CONSERVATION TEAM CONSULTATION APPLICATION RESPONSE

APPLICATION REF:	25/02330/FP & 25/02331/LBC
CASE OFFICER:	AHD
APPLICATION SITE:	1 John Street, Royston, Hertfordshire SG8 9BE
DESCRIPTION OF WORKS:	Change of use of existing offices into 6 bed HMO (Class C4). Internal alterations to facilitate change of use of existing offices into 6 bed HMO (Class C4).

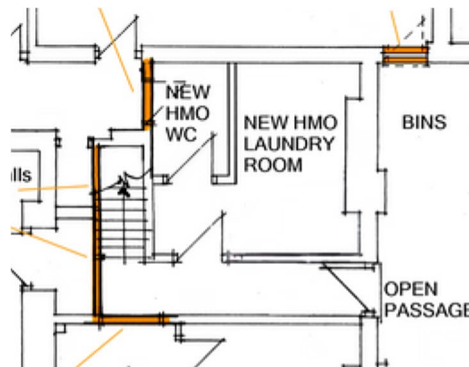
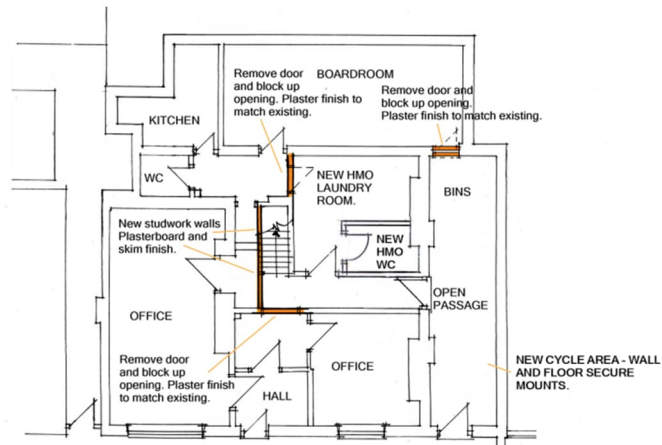
I previously stated that the WC serving the HMO would impact upon the proportions of the central room and which also includes a fire surround which is in the style of the most common Regency fireplace pattern with reeded jambs and corner roundels. I note that the ground floor plan has been amended and the agent has confirmed that a WC would remain on the ground floor plan but would only be implemented, if specifically asked to do so by the local authority for the HMO license application.

The revised plan below is unobjectionable.

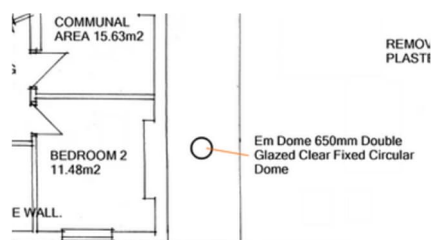
I have previously suggested that the applicant be encouraged to introduce a roof light onto the single-storey flat roof and which would then provide natural light to the HMO entrance door in what is currently an unappealing covered area.

I am pleased to note the proposed double-glazed dome over this passageway on the revised drawing extract below and is unobjectionable.

PROPOSED FIRST FLOOR PLAN. 1:100.

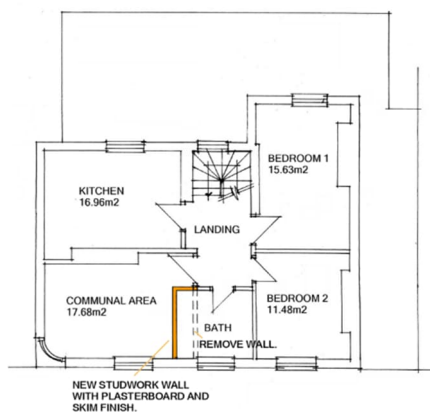
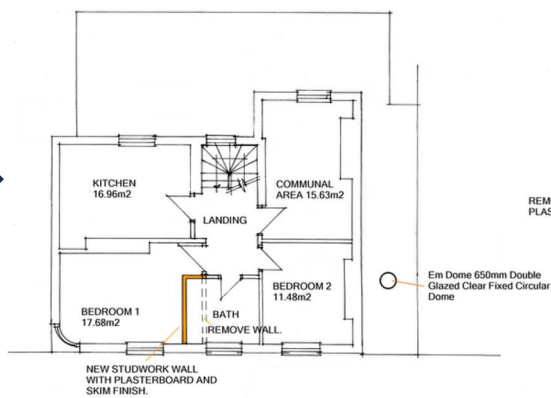
At first floor floor a wall is proposed to removed and a new studwork wall introduced to create a bathroom.

Following my communications with the Planning and Environmental Health Officers in recent weeks I note that the bedroom and communal room have been swapped on the first floor and I am happy with proposed secondary glazing as detailed on drawing no. 102 Rev D albeit the detail is a little basic.

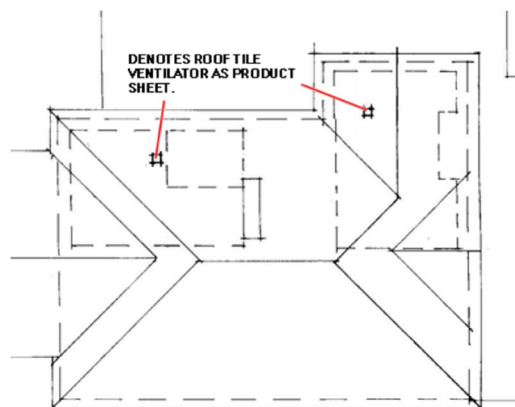
At second floor, two doors and a small section of non-original wall is proposed to be removed and a sliding door introduced.

With reference to the same communications with the Planning and Environmental Health Officers I am aware that a System 4 mechanical extract ventilation with heat recovery (MVHR) system is proposed to be installed. I note that vents are in situ in both of the top rear rooms, and are 125 mm in diameter and that there are no period features on either of the top floor ceilings. Furthermore, the roof vents would be on rear roof slopes and would not be visible from the street as indicated on the roof plan below. This is considered unobjectionable.
